ISSUE: Addition and alterations

APPLICANT: St. Paul's Episcopal Church

LOCATION: 228 S. Pitt Street

BAR CASE #2006-0053
June 7, 2006

Original Proposal, Duke Street Elevation

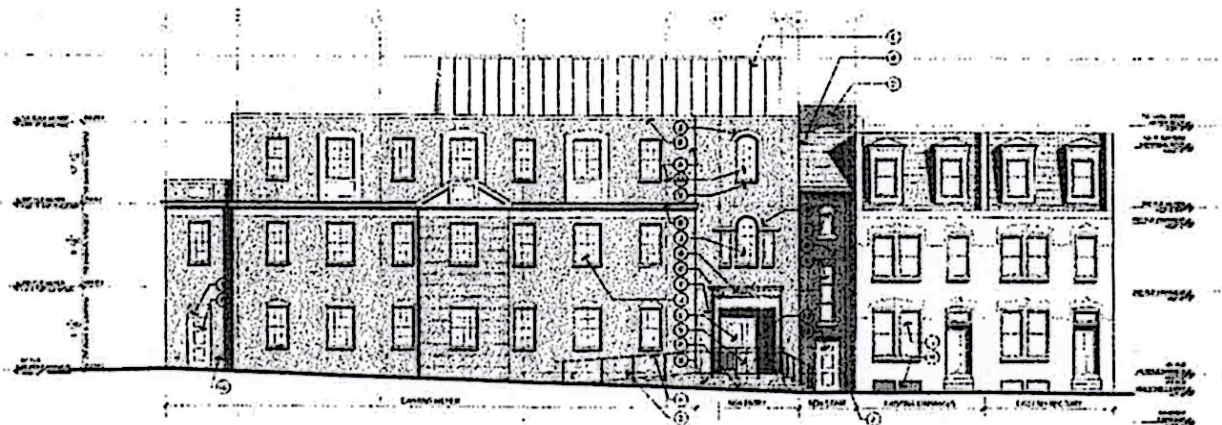
proposed alterations included new bay window and new large institutional entry

Revised Proposal, Duke Street Elevation, bay window eliminated and entry revised

Wilmer Hall entrance bay alterations- Staff believes the new wider entranceway with combined steps and handicapped ramp is an appropriate solution to provide accessibility for Wilmer Hall. This allows the Pitt Street entrance, which was designed as the primary entrance, to remain unaltered. The revised design of the entranceway, with narrower opening and lighter surround is compatible with the Colonial- inspired detailing of Wilmer Hall and with the smaller scale residential entrances of the single family houses along the 400 block of Duke Street. Although the shield motif remains in the railing at the landing, Staff is no longer as concerned about the institutional character of this element, given the other positive changes that have been made to the redesign of this bay. Staff recommended that the applicant use discrete signage, rather than irreversible architectural changes to signal the use of the building and this bay. The applicant is now showing a small sign above the door. Staff does recommend that to the greatest extent possible, existing brick be salvaged to infill the arched entrance to the left of the new entrance, rather than using new brick.

Most notable among the recent changes is the elimination of the proposed new two story metal window. Staff and Board felt that this bay was visually overwhelming and incompatible with the building and surrounding residential neighborhood. In addition, the new bay required the elimination of the existing tripartate Palladian window that Staff believed to be significant to Smith's design for Wilmer Hall. The elimination of the proposed bay window and the scaling down of the entranceway allow this easternmost bay of Wilmer Hall on Duke Street to read as an integral part of the original building. The very minimal alteration proposed for the third story window is compatible with the vocabulary of the 1955 building.

Wilmer Hall - A new entrance will be created on the south side of the building facing Duke Street in the easternmost bay. The existing window and arched entrance vestibule will be replaced with a new, larger accessible entrance. The area to the left of the new entranceway will be infilled with brick similar to the existing. A brick sample will be available at the hearing. The new entranceway will be centered below the Palladian window in the second story and will have a simple painted wood surround and entablature. The 7' wide entranceway will open onto a 9' wide vestibule area and then to a pair of natural finish wood and glass doors. The doors will have sidelights and each leaf of the doors will have four rectangular lights. There will be recessed down lighting within the vestibule area in front of the doors and thus no exterior lighting fixtures. This proposed new entranceway is somewhat narrower than the previous design and has a lighter, wood surround. Also new is the black pin-mounted letter sign reading "Saint Paul's" on the entablature above the new entranceway.

On the second floor above the entranceway, the existing tripartite Palladian style window will remain. On the third story, the existing rectangular window head with flat lintel will be replaced an arched window surmounted by an arched lintel of a soldier course of rubbed brick. The two story metal bay that had been proposed for this area in the previous submission has been eliminated.
